MEMORANDUM

Reference: DA20/0729

Subject: Torrens Title Subdivision of 2 into 3 lots and Construction of Three x Two Storey Boarding House with Associated Fencing, Car Parking, Tree Removal, Landscaping and Drainage Works – 31 & 32 Park Avenue Kingswood NSW 2747

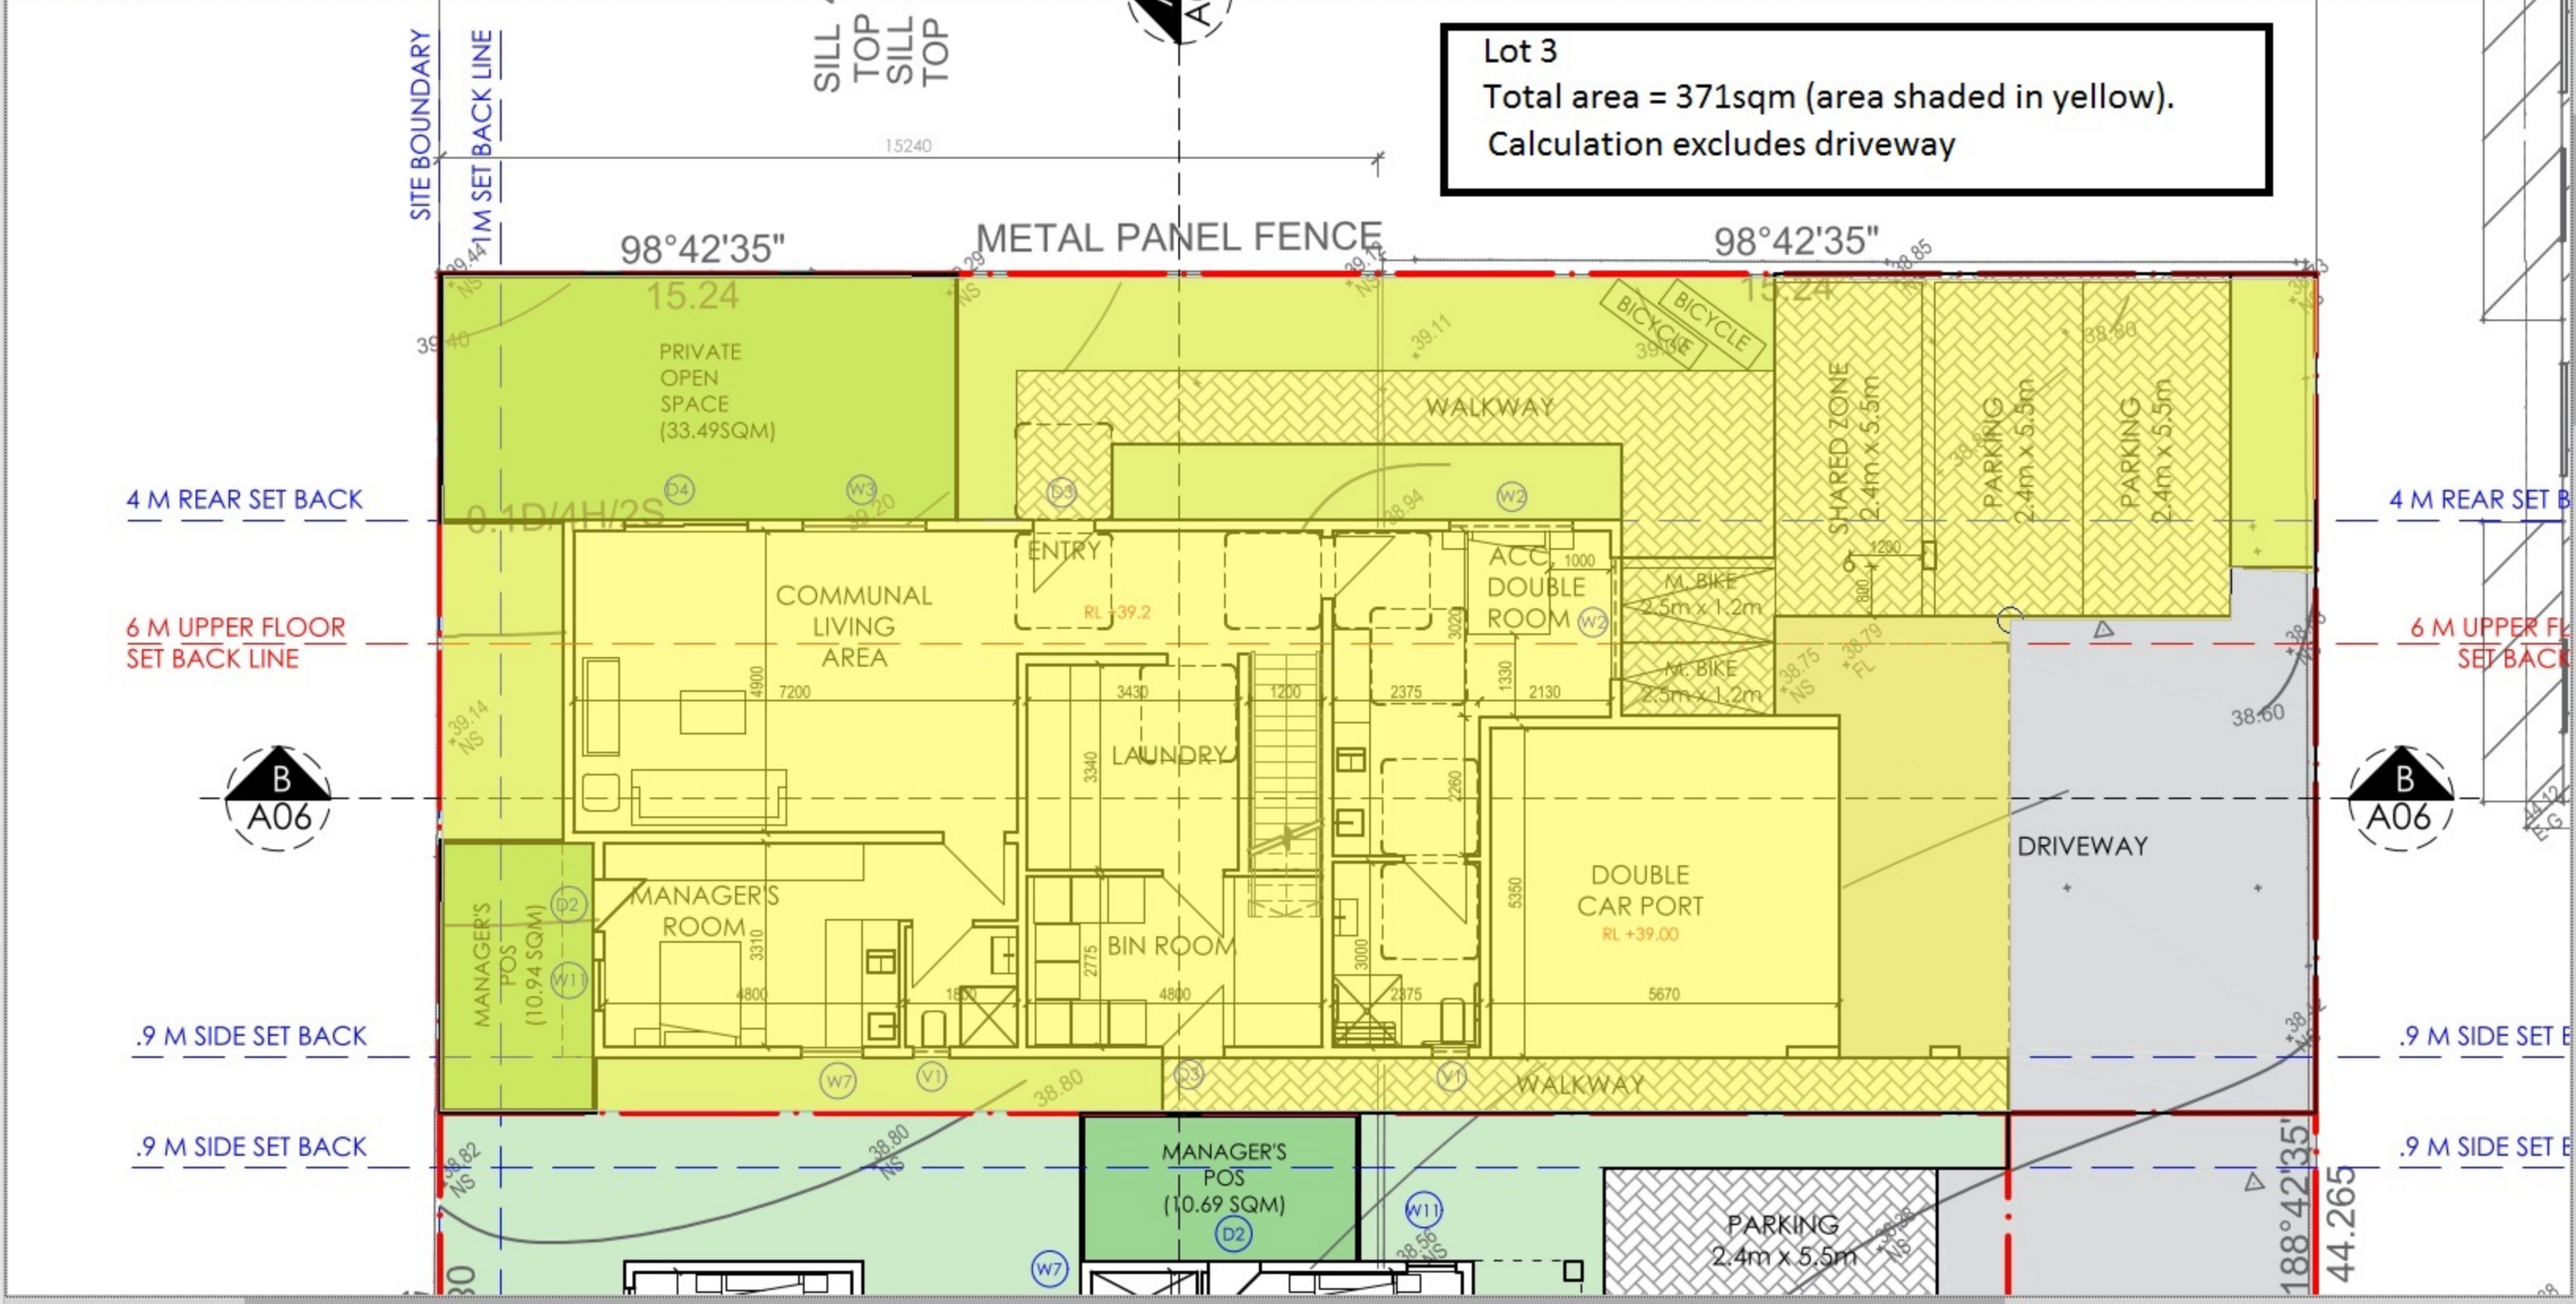
2. Lot 3- Calculation of Area

The area of Lot 3 as calculated in the Applicant's Clause 4.6 Request differs from the calculation provided in Council's assessment report.

The attached plan of Lot 3 shows the measured lot area as calculated by Council staff, as shaded in yellow.

Using Council's online measuring tool, the area of Lot 3 has been calculated as 371sqm. This calculation excludes the area that is used as an access handle in accordance with Clause 4.1 (4C) of Penrith LEP, which states:

Whilst Penrith LEP and DCP do not define an access handle, in this instance the access handle has been taken to include all parts of the driveway that facilitate direct vehicle access into the lot, and any shared access. The car parking spaces at the rear of Lot 3, and the part of the driveway that forms the carport entrance have been excluded from the access handle (and been included in the lot area).
